# **M1 PACIFIC MOTORWAY REPLACEMENT AND WIDENING TUGGERAH TO DOYALSON**

## **Submissions Report**

**OCTOBER 2014**

Figure 1 Construction exclusion zones within study area based on flora and fauna habitat surveys - southern section

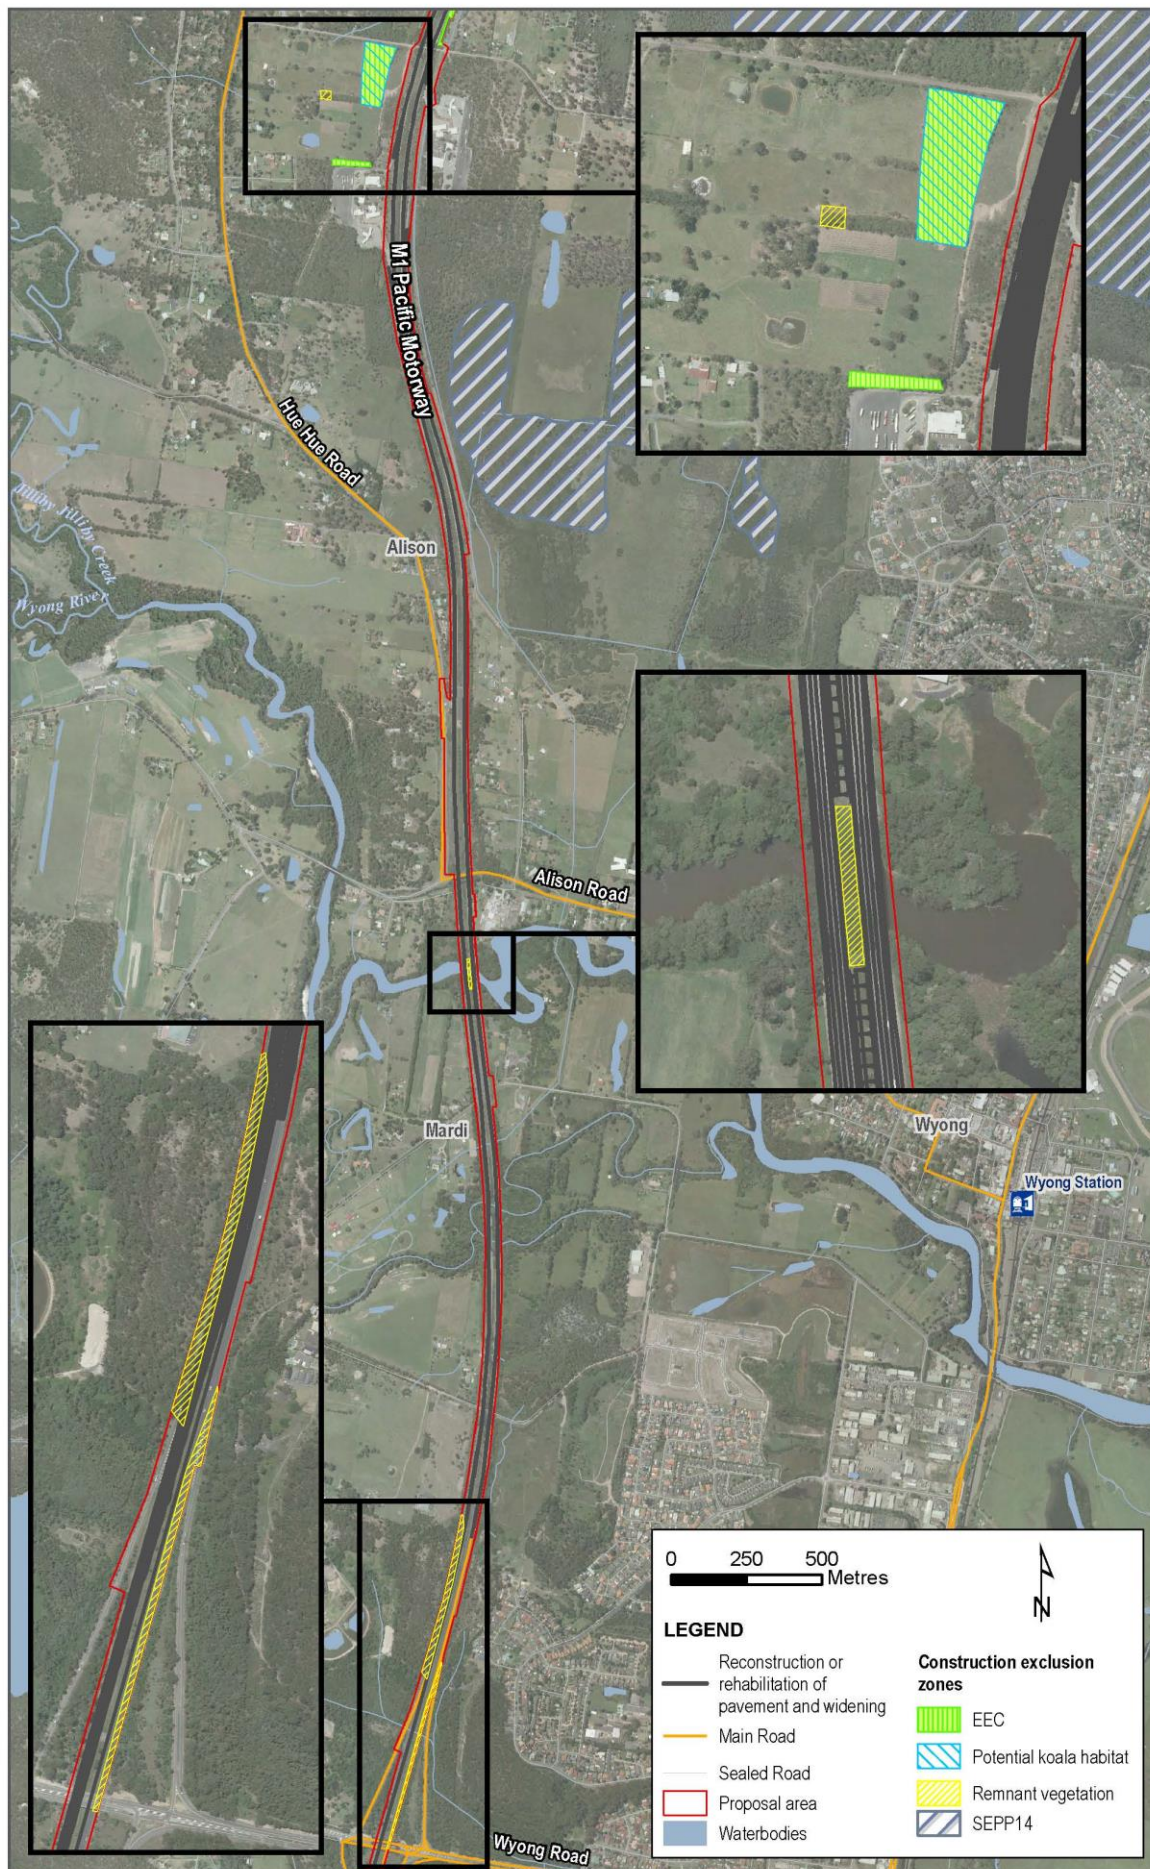
Changes to the proposal safeguards and management measures are required as a result of the proposed geotechnical and utilities investigations. The change is related to modification of the proposed exclusion zones. The amended safeguards are provided below.

| No. | Impact  | Environmental safeguards  | Responsibility                                | Timing           |
|-----|---|---|---|------------------|
| 46  | Minimise impacts of the proposal on EECs and SEPP 14 wetlands | <ul style="list-style-type: none"> <li>Offsetting for impacts on EEC vegetation should be investigated in accordance with the Roads and Maritime Guideline for Biodiversity Offsets (2011).</li> <li>Where reasonably practicable, retain vegetation that contains EECs present in the proposal area and adjacent sites.</li> <li><del>Exclusion zones detailed in Figure 6-12 and Figure 6-13 are to be established and maintained throughout construction. Ensure that exclusion zones are fenced off and signage erected in accordance with the Roads and Maritime Biodiversity guidelines: Guide 2 – Exclusion Zones (RTA, 2011).</del></li> <li><b>Exclusion zones detailed in Figure 1 and Figure 2 of the Submissions Report are to be established and maintained throughout construction. Ensure that exclusion zones are fenced off and signage erected in accordance with the Roads and Maritime Biodiversity guidelines: Guide 2 – Exclusion Zones (RTA, 2011).</b></li> </ul> | Roads and Maritime<br>Construction contractor | Pre-construction |
